FIELD SERVICE BULLETIN

FSB Number: LVCCFSB2005-15
Author: Tony Bryan
Date: January 27, 2005
Total No. of Pages: 3
Subject: GSM Triplets Refresh (V600R) – Flip Detect Switch
Phone Models: GSM V620, V600i
Level of Repair: 2

Fig. 1.0 – Cross-Section showing uneven compression force on flip detect switch, concentrates contact area on a small portion (right side) of the PCB contact area.

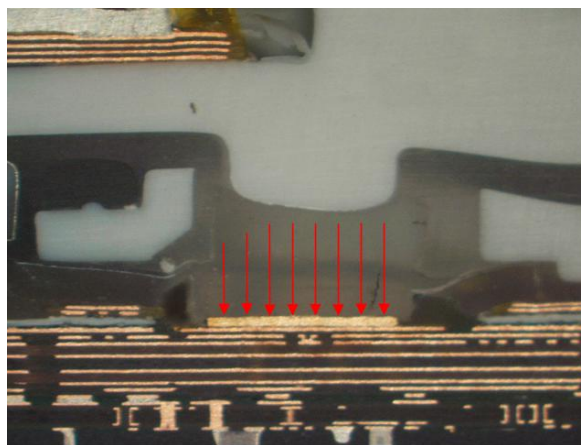
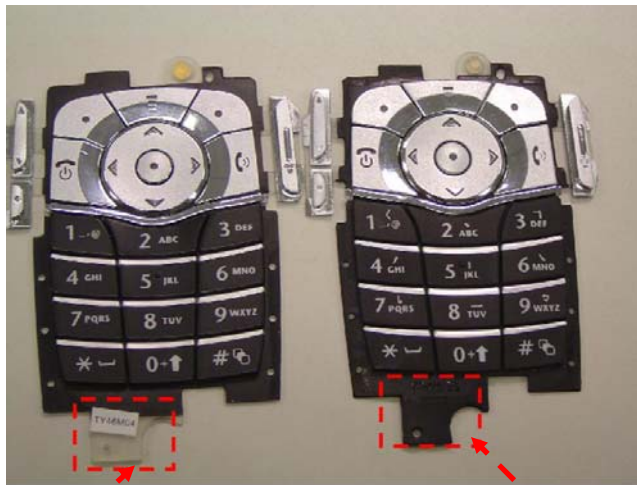
Service is aware of an issue, identified during the NPI Analysis on GSM V620/V600i. Some units, returned with customer complaints related to improper operation of the “Secondary/External Display” were found to have an intermittent problem where the flip detection switch would not activate when the flip was closed. Analysis revealed the issue to be caused by a poor or uneven compression force between the keypad gold puck and the flip switch contacts on the PCB. See Fig. 1.0 below.

Note: V620/V600i hardware included a fix for an issue where the main display lens would be scratched by the keypad. This fix combined a thinner main display lens and added height to the rubber base bumpers. This is a factor which is contributing to this failure mode.

The failure rate for this issue was much higher on units built with ITT keypads versus units built with TeeHwa keypads. Analysis of the keypads found, although no keypads were found to be out of specification, some of the keypads were at the low end of the tolerance and that was the reason for the higher failure rate.

Short-Term: (1) Factory took immediate action. A shim was added to the functional testing for flip switch operation. The shim holds the flip open an additional 1mm higher than in normal use to screen out units with potentially weak compression on the flip switch. – WW43 '04.
(2) All ITT keypads were purged from the factory as well as TeeHwa keypads that were found to be on the low end of the tolerance for gold puck height. Only TeeHwa keypads, measuring on the high end of the tolerance, are used. – WW48 '04.

Long-Term: (1) Keypad 3888470Yxx Rev. B - Modify keypad plunger to create chamfered surface to allow for more uniform compression. - February '05
(2) Flip Front Housing 0188382N03 Rev. G - Modify flip inside housing flip detect protrusion to account for flip bias due to hinge spring. This will better align the flip detect protrusion with the keypad plunger/gold puck. - April '05
(3) Side-Key Flex 8489088N04 Rev. D - Modify side-key flex to pull back adhesive from around flip detect switch opening to reduce opportunity from foreign material to collect around the PCB contacts. – March '05
